American Champion Aircraft Corp.
Rochester, WI 53167

Service Letter: 406 (page 1 of 3) Revision A

Title: Wood Spar Inspection

Models: All Model 7's, 8's and 11's with wood spar wings

Figure 1 Crack Location

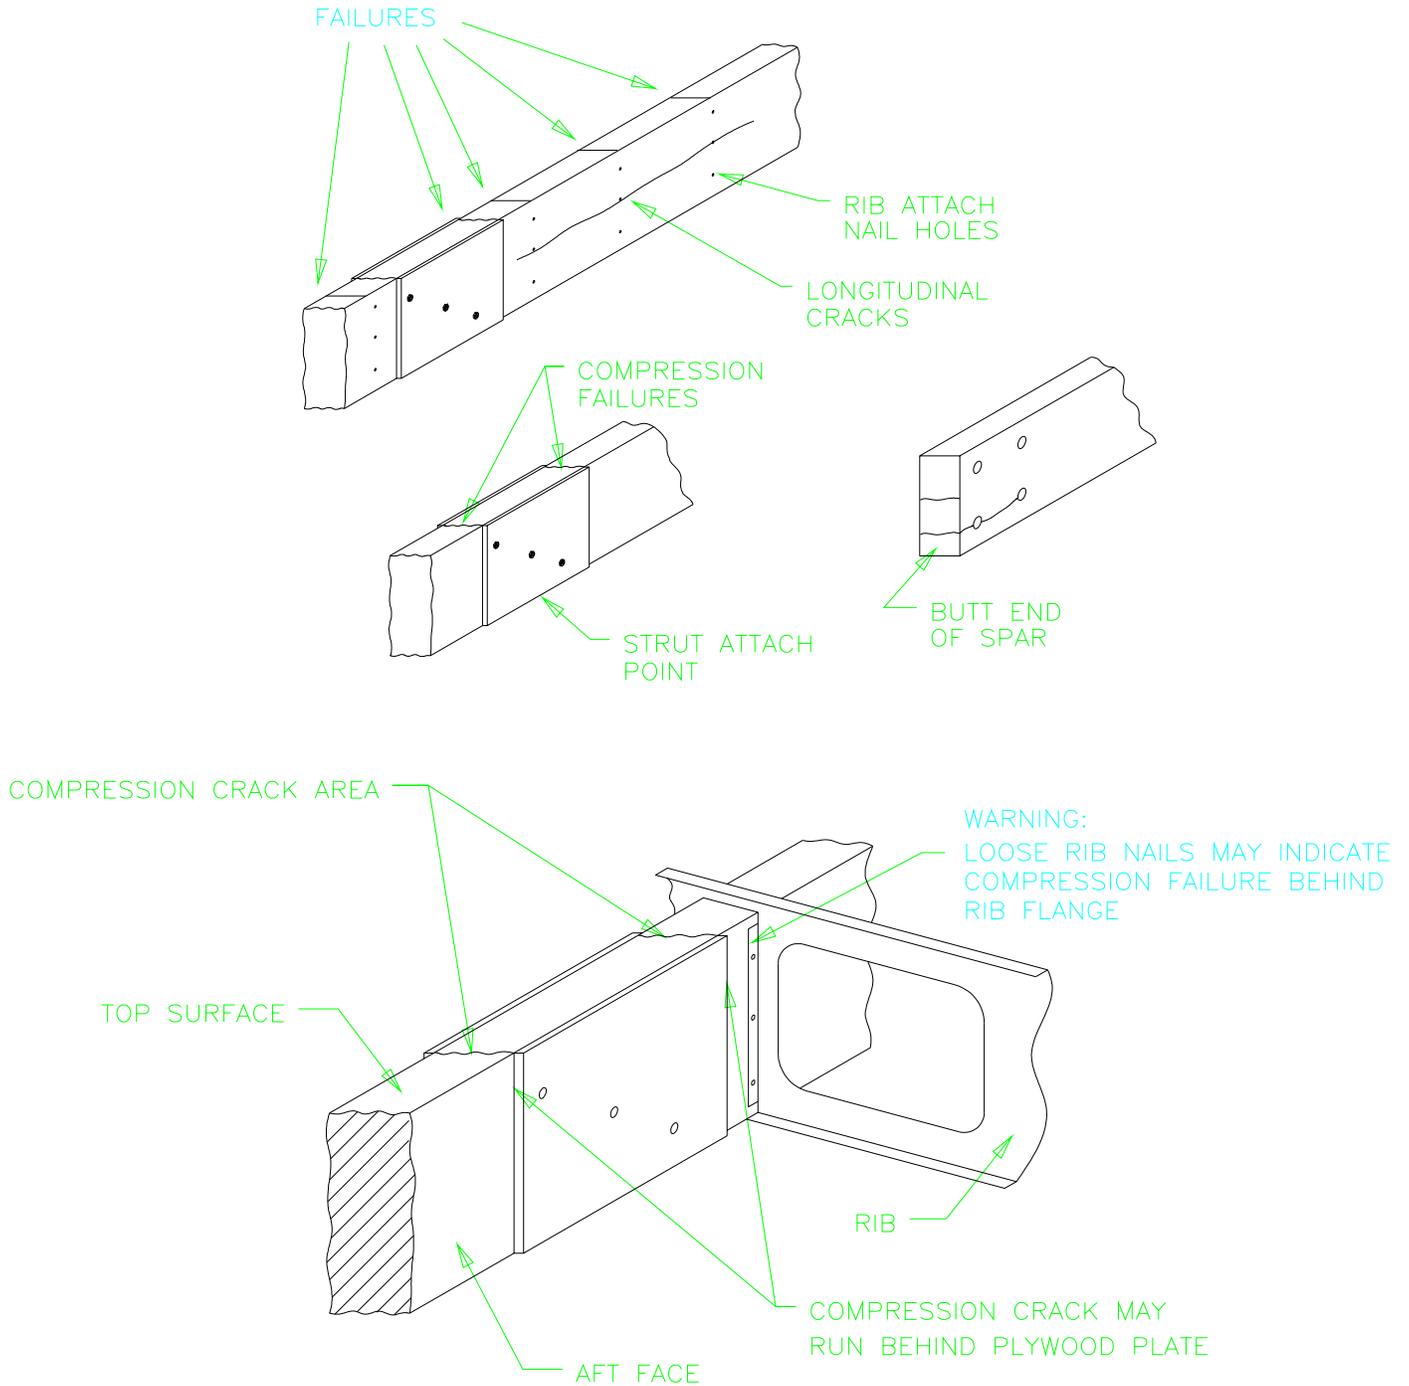
Description: There have been reports of cracks developing in wood spars, both front and rear. There are many possible causes to the cracking including: high flight time, wing damage history, high acrobatic time, over-stress history, or having been exposed to changes in humidity over several years. Compression cracks have been found emanating from the upper and lower surfaces of the front and rear wing spars at both ends of the reinforcement plate for the lift strut attachment. Longitudinal cracks have been reported in all areas of both front and rear spars, including through the wing root. See figure 1 for example locations of spar cracks.

Inspection: The only area where it is possible to positively identify a compression crack is on (Bottom/Top) the top and bottom surfaces of the spar. Both front and rear spars need to be inspected. The key areas to be concerned with are shown in figure 1. Additional inspection holes may be necessary to do a thorough inspection. Service Letter 417, Revision C, may be used as a guide for installing additional inspection holes.

Inspection: Remove all wing inspection covers and wing root gap cover. Using traditional (Sides/Ends) methods, (such as flashlight and mirror) inspect full span along the front and rear wing spars for longitudinal cracks through bolt, nail, and spacer holes. Inspect the butt end of both spars for cracks. Additional inspection holes should be added as necessary to do a thorough inspection and check all areas of concern. Service Letter 417, Revision C, may be used as a guide for installing additional inspection holes.

Instructions: If any damage was found in above inspections, it requires that the spar be repaired or replaced. Minor chafing and small indentations are not cause of rejection. Spar repair shall be accomplished in accordance with AC 43.13-1A Acceptable Methods, Techniques and Practices or other Federal Aviation Administration approved data.
